NM1 - 8

GENERAL CORRESPONDENCE

T-N-T Construction, Inc., Tony Schmitz, President, Star Route, Linderoth, New Mexico, 87029, has submitted for approval an application to enlarge the previously approved commercial evaporation facility located in the SE/4, Section 7, Township 25 North, Range 3 West (NMPM), Rio Arriba County, New Mexico. The application proposes to add a second native clay lined evaporation pond to the facility for use as an overflow for excess water from the existing approved evaporation pond. The permit application addresses the construction, operations, spill/leak prevention and monitoring procedures to be utilized at the site. The ground water most likely to be affected by any accidental discharges is at a depth of approximately 150 feet, with a total dissolved solids concentration of approximately 1300 mg/l.

The attached information and permit application are submitted for your review and approval. The information addresses the material required in the New Mexico Oil Conservation Division (OCD) "Guidelines for Permit Application, Design, and Construction of Waste Storage/Disposal Pits" (revised 2/88) and Rule 711 of the Division's Rules and Regulations promulga

Figure 4. Monitor well construction, cross-section.

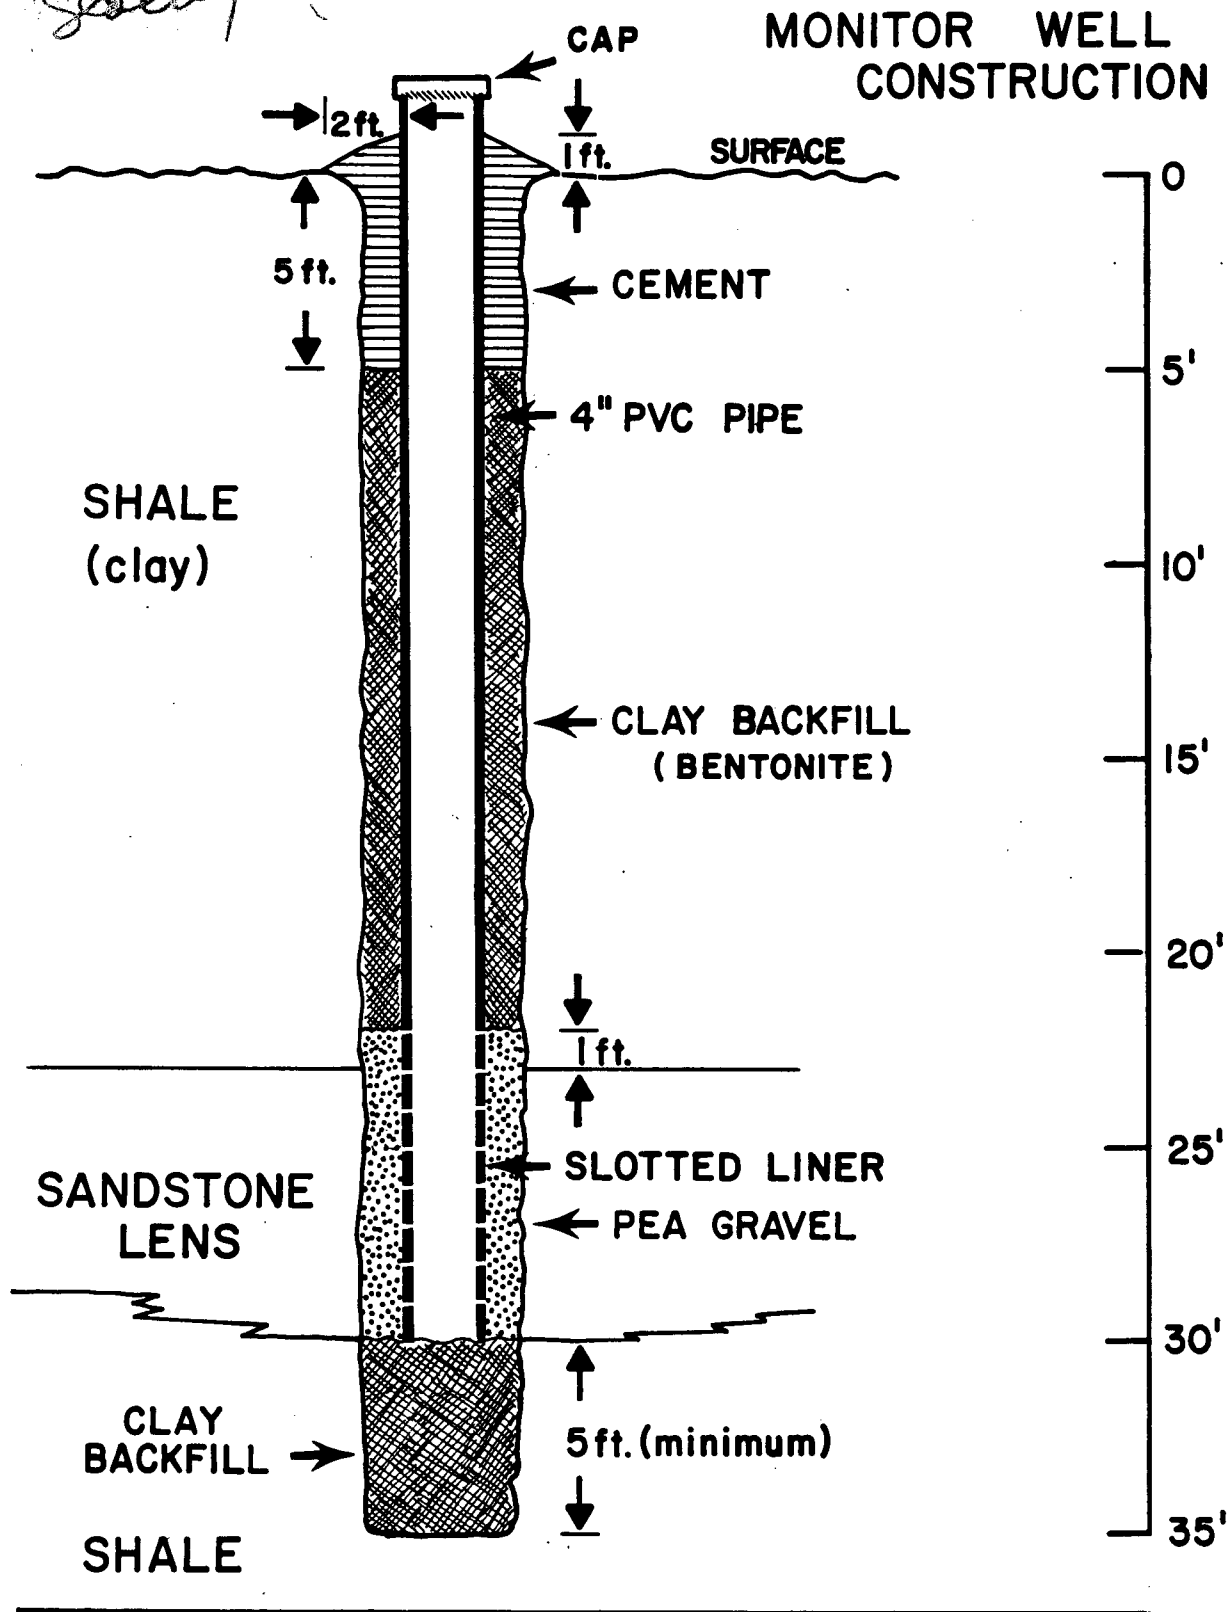
*Kind of
slitting?*
